SB, Stator change, DM400, DM430, 2020-06

DM400 and DM430, from serial no: U8J202017400002.

Figure 1: Old stator (current system)

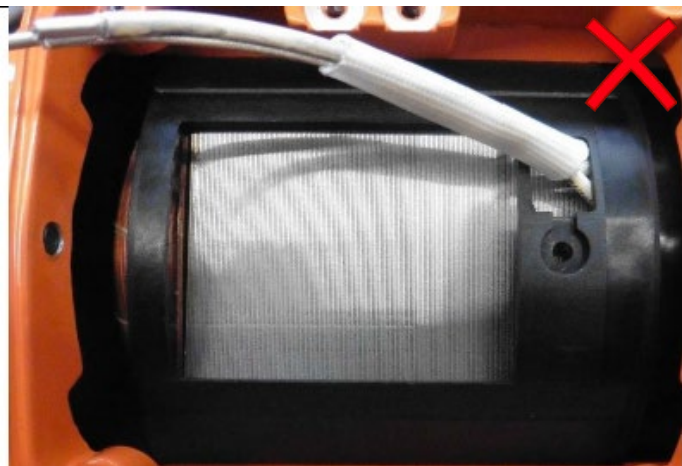
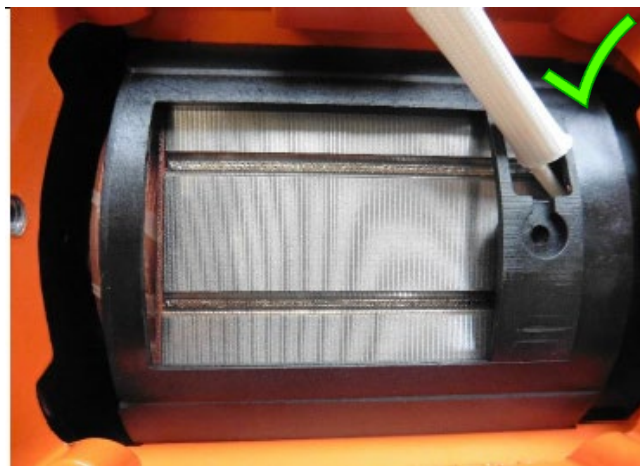
A new modern manufacturing system for the DM400 / DM430 Stator has been introduced. As a consequence we need to change the Screw that connects the electronics board with the stator (figure 3 and 4) in order to ensure proper EMC suppression. The Stator itself is backward compatible.

When a Stator is changed to the new type, the Screw 598809301 needs to be changed to 599980801 on the electronics board as well.
